Millstone Nuclear Power Station, Unit No. 3
Transmittal of Responses to Requests of Additional
Information and Draft SER Open Items (Geotechnical Issues)

RESPONSE OR SCHEDULE FOR
SUBMITTAL OF RESPONSE
TO GEOTECHNICAL MEETING ACTION ITEMS
(241 SERIES QUESTIONS)

SUBJECT: Meeting Summary - February 14, 1984
Discussion of 241 series Questions and
Draft SER Geotechnical Open Items

RESPONSE TO REQUESTS FOR
ADDITIONAL INFORMATION
ACTION ITEMS RESULTING FROM FEBRUARY 14th MEETING

FIGURE 2.5.4-67
GEOLOGIC PROFILE
SECTION N-N'
MILLSTONE NUCLEAR POWER STATION
UNIT 3
FINAL SAFETY ANALYSIS REPORT

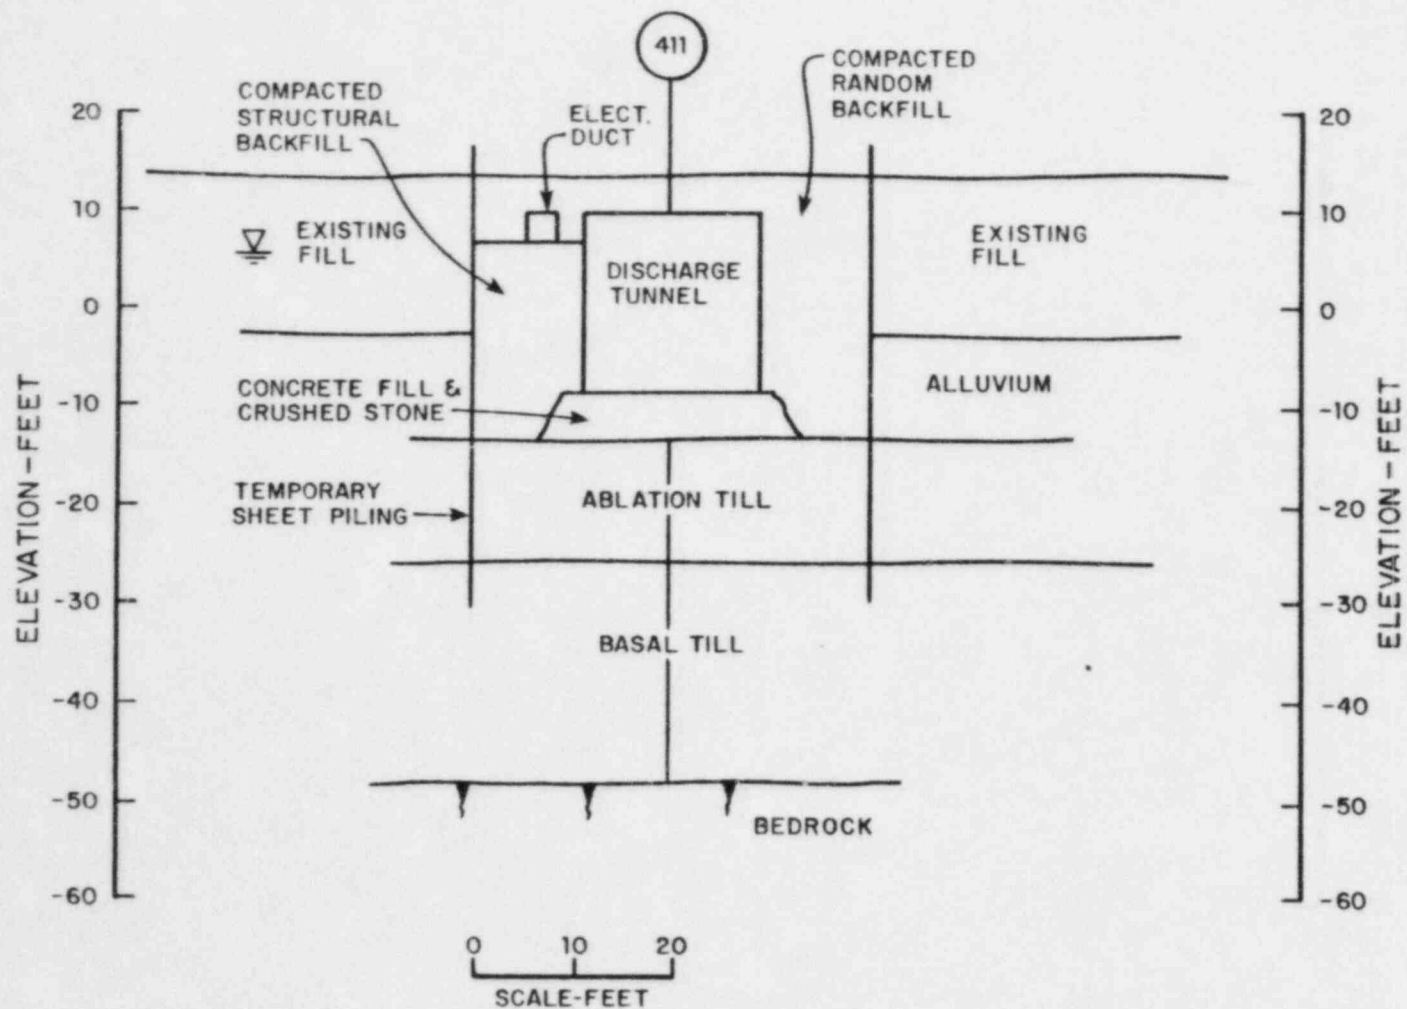
Mr. Chen asked if the sheet piling shown along the discharge tunnel had been removed. Upon being informed

that the water indication to the left of the discharge tunnel was fill, not water, this question was resolved.

Action: The Figure will be revised to clarify fill to the left of the discharge tunnel.

Figure 2.5.4-67 has been revised.

FIGURE 2.5.4-72
 SOIL-STRUCTURE INTERACTION
 EMERGENCY GENERATOR ENCLOSURE
 MILLSTONE NUCLEAR POWER STATION
 UNIT 3
 FINAL SAFETY ANALYSIS REPORT

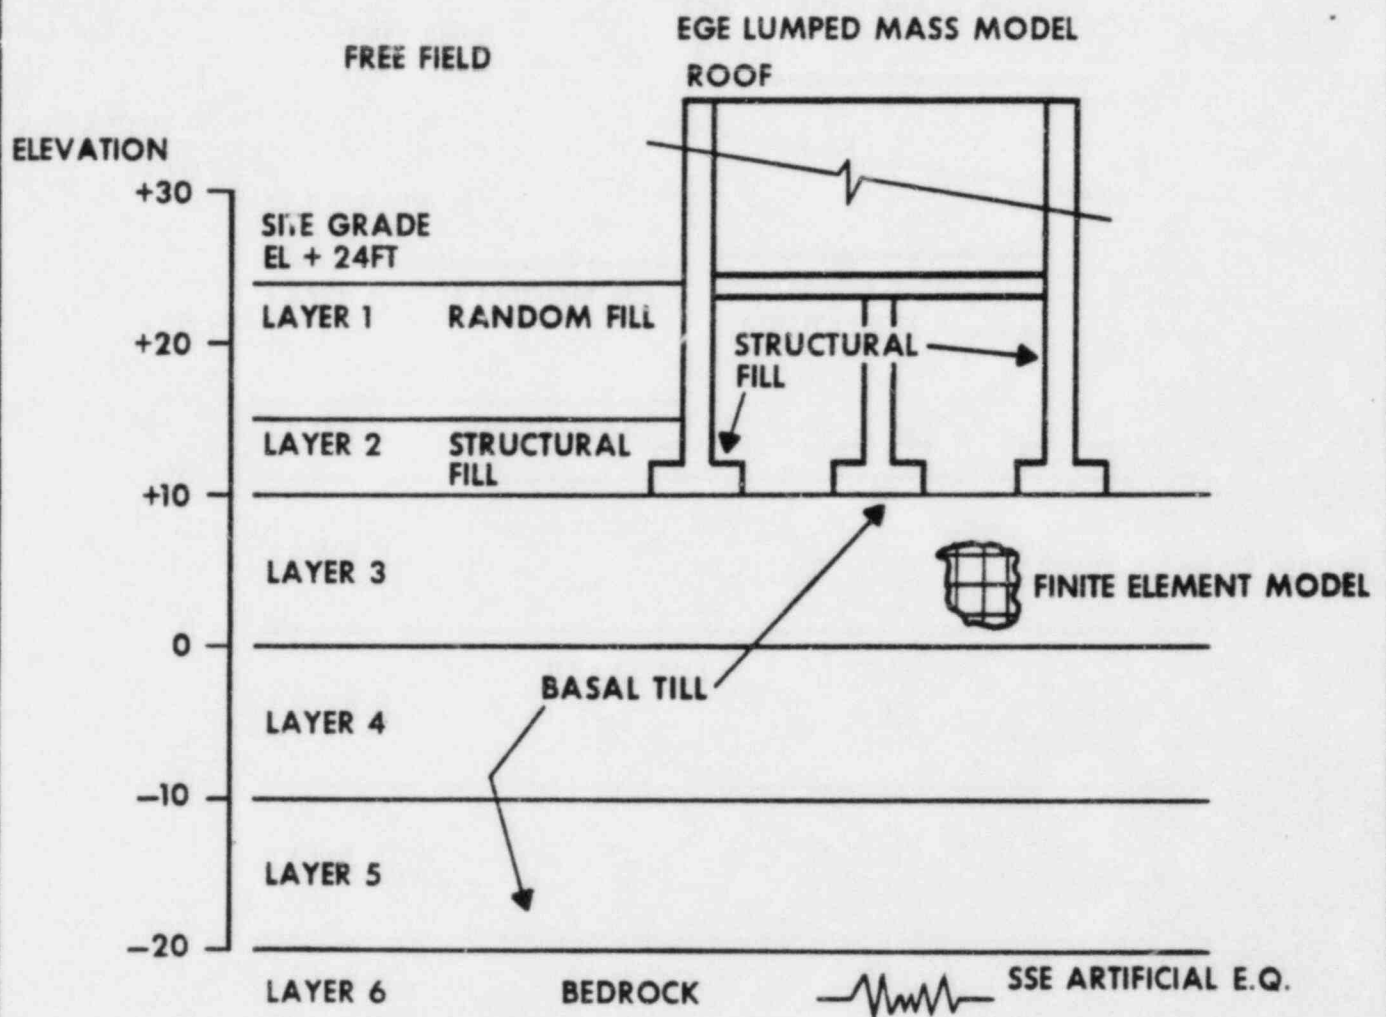
- c) Mr. Chen expressed concern over the variance of shear modulus in the till across the section show (EGE and Control Building) and also the same effect of the compacted fill adjacent to the Control Building.

Action: F. Vetere will do parametric study of varying G_{max} of till for range of ν_s on page 2.5.4-9 of the FSAR and tabulate G_y for various G_{max}

Figures 2.5.4-72, -73 and -74 show the EGE Soil Structure Interaction, Shear Modules Curve, and Sampling Curve, respectively.

FIGURE Q241.6-1
SLIDING STABILITY OF THE
SERVICE WATER ENCASEMENT
MILLSTONE NUCLEAR POWER STATION
UNIT 3
FINAL SAFETY ANALYSIS REPORT

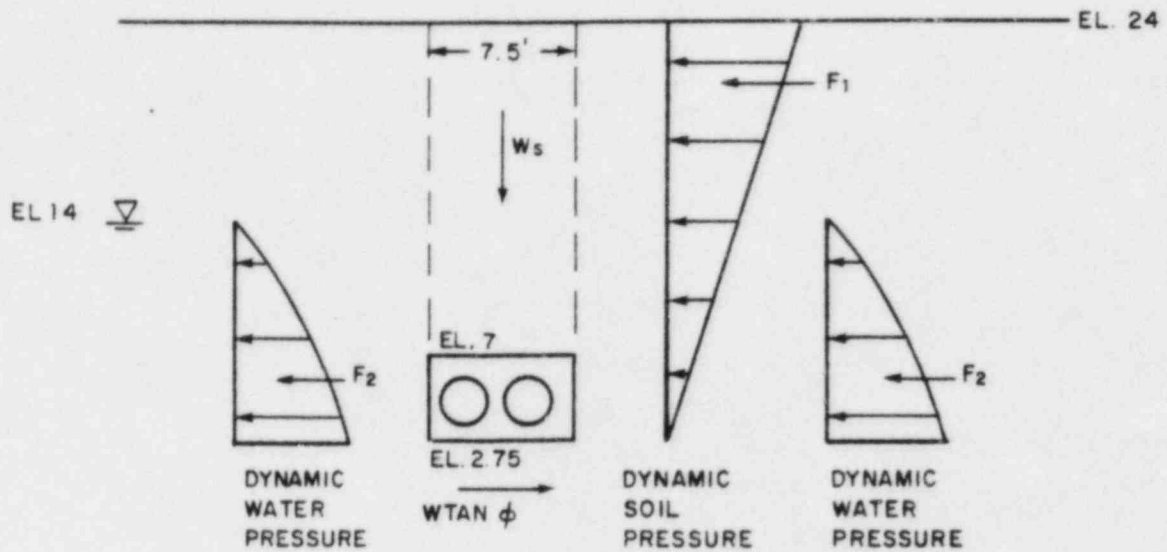
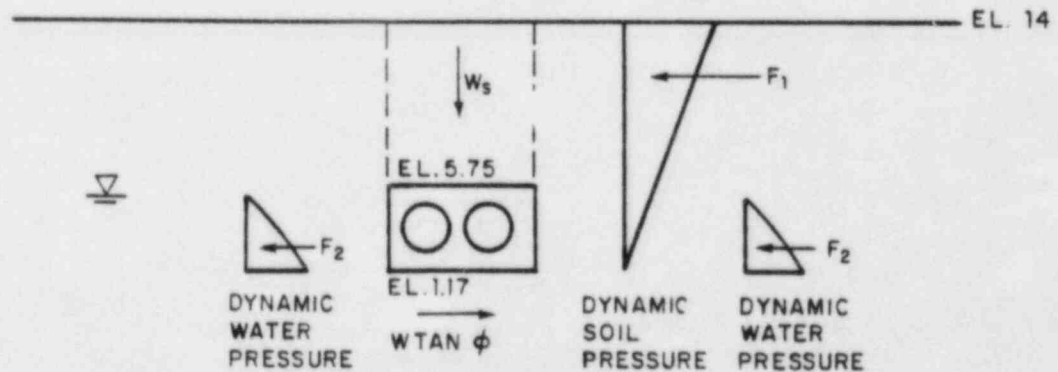
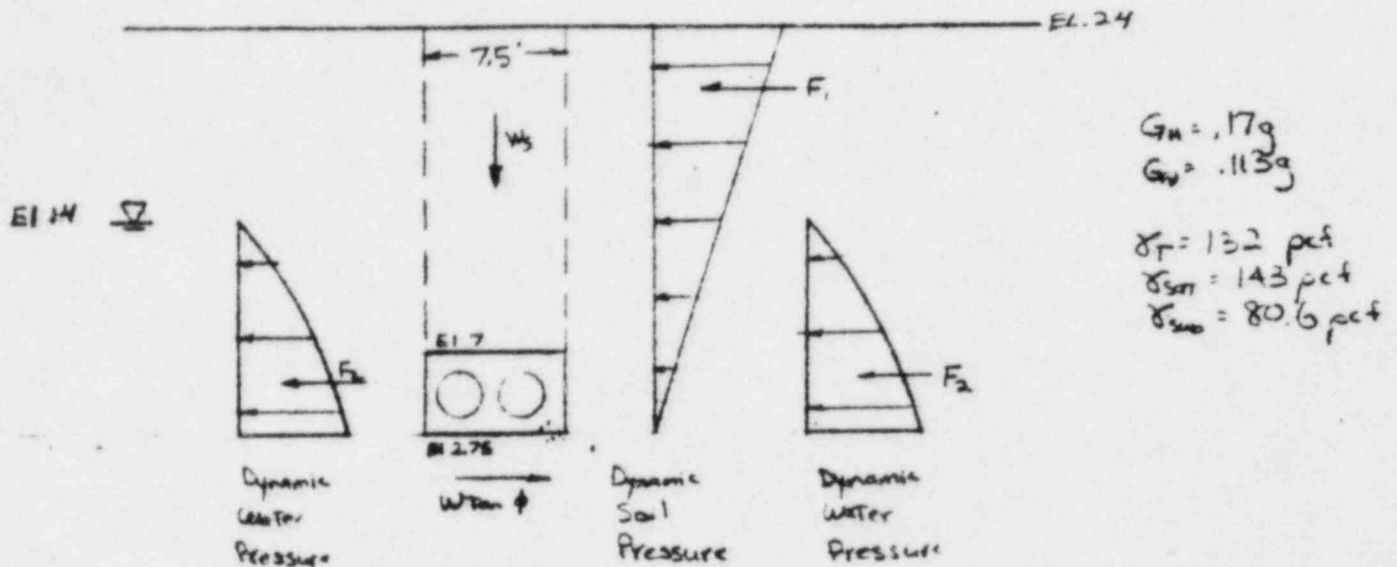
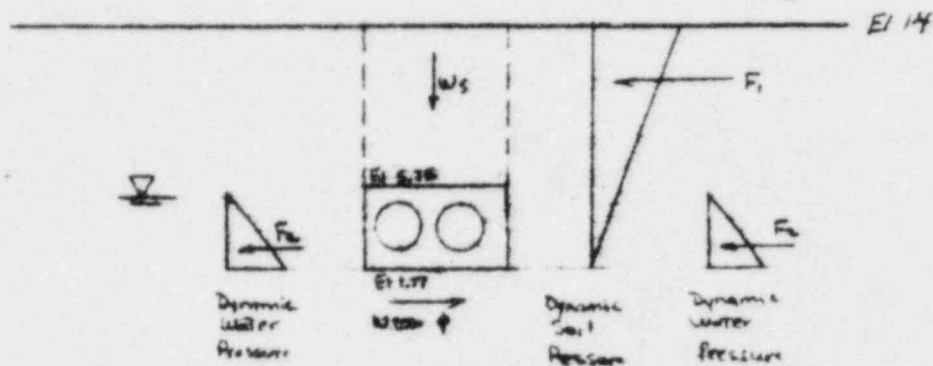
Sliding Stability calculation does not account for top driving force.

Action: F. Vetere will reanalyze this, adding dynamic driving force from ground surface to bottom of pipe when considering the weight of soil as a benefit.

You state that the service water encasement has been analyzed for sliding stability due to seismic loading. Provide the details of the analysis and identify the cross-section used in your analysis. 1.13
1.14

A revised response to Q241.6--Sliding Stability of the Service Water Encasement and corresponding calculations are provided.

$$FS = \frac{\text{Resisting Forces}}{\text{Driving Forces}} = \frac{(1816.6 + 14131.5)(0.4)}{3612.5 + 2(548.2)} = 1.35$$
